RURAL NEIGHBORHOODS
BID PACKAGE – ADDENDUM #1
CONSTRUCTION OF COMMUNITY CENTER at
Esperanza Place, Immokalee, Florida

Project Name: Eden Park – Esperanza Place Community Center

Addendum Info: Addendum #1 issued December 10, 2021

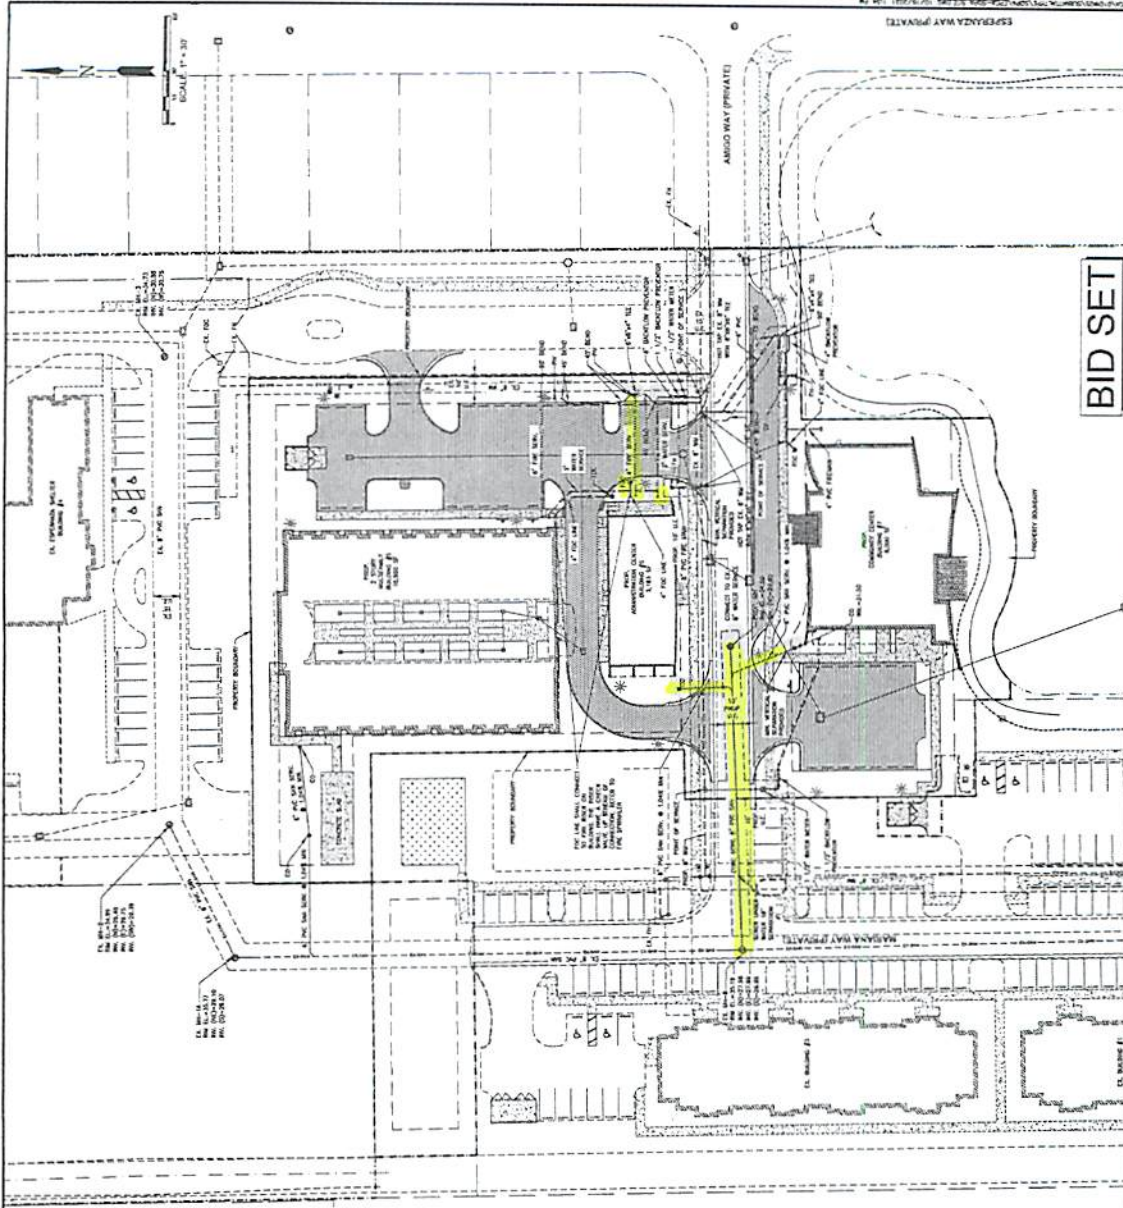
1. Civil drawings do not depict water, fire, or sewer line connections needed as part of the site development for this building.

Response: *The drawings on the next page highlight the connections needed. A sewer main is needed as highlighted with branches running north to the community center and south to approximately 2' beyond the edge of the road. The fire line must be extended from the east side of the property and connected to the community center and must include the FDC. Connections to the community center are needed for the domestic water line. Estimates for this work must include cutting and patching existing roadway, curbs, and sidewalk as needed for installation of these underground utilities.*

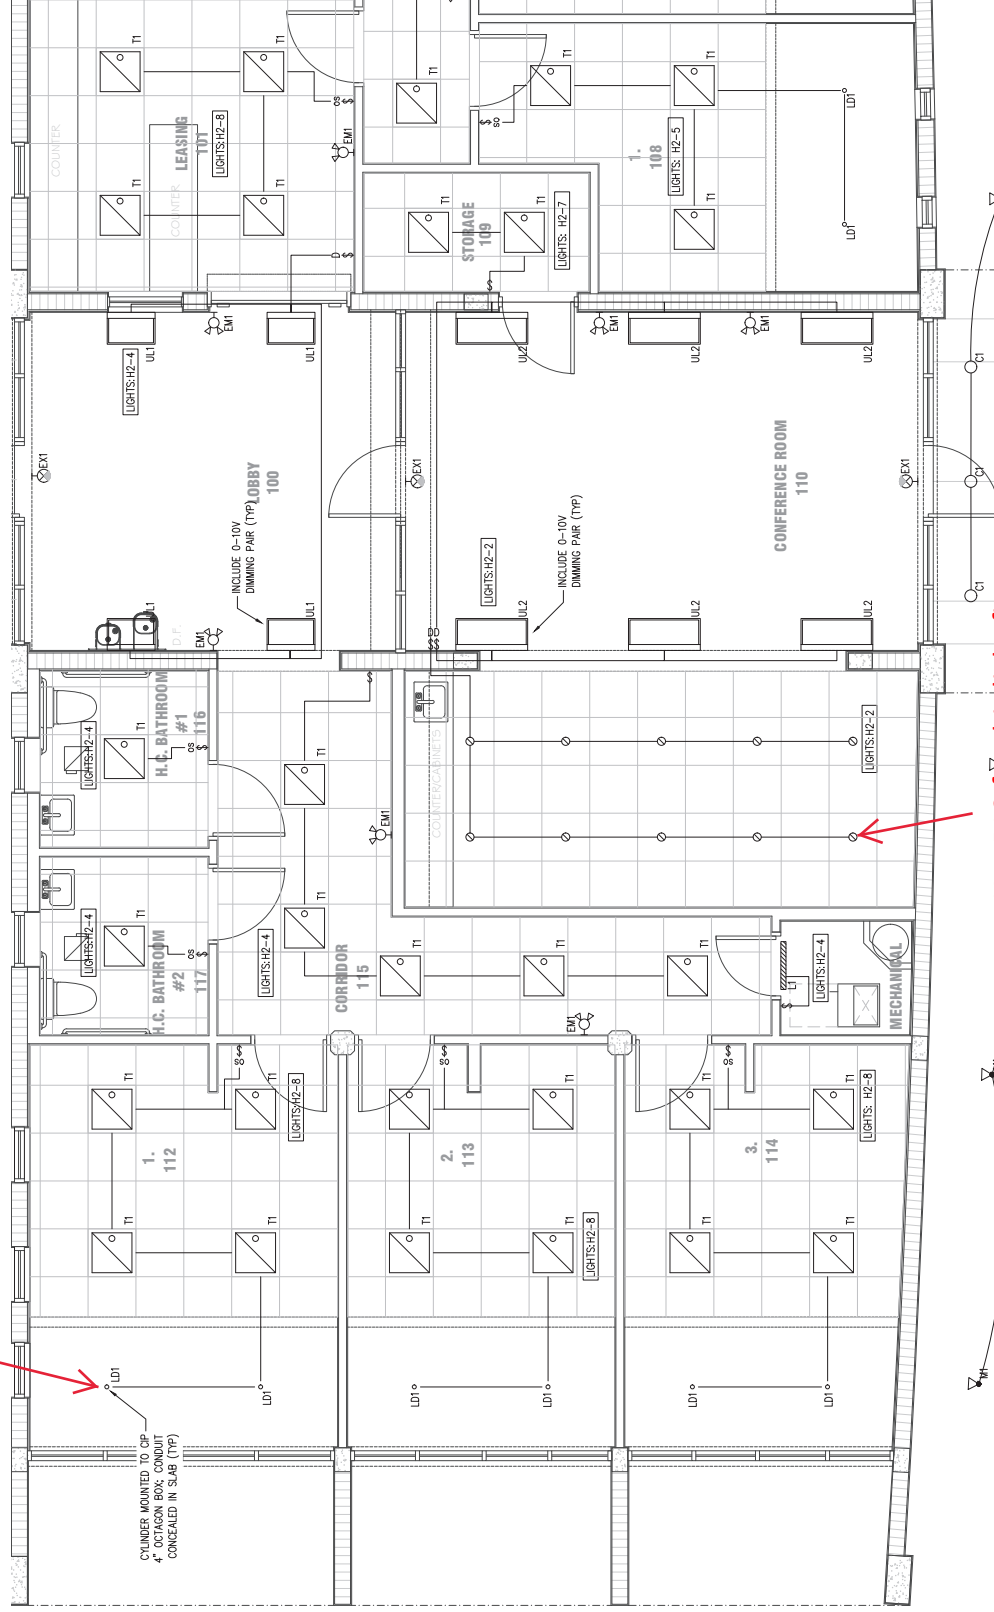
7. Please clarify the type of lights called for on Page E2.00.

Response: *See notes on drawing on next page.*

This is a typo, use light fixture DL1

Use DL2 for this light fixture
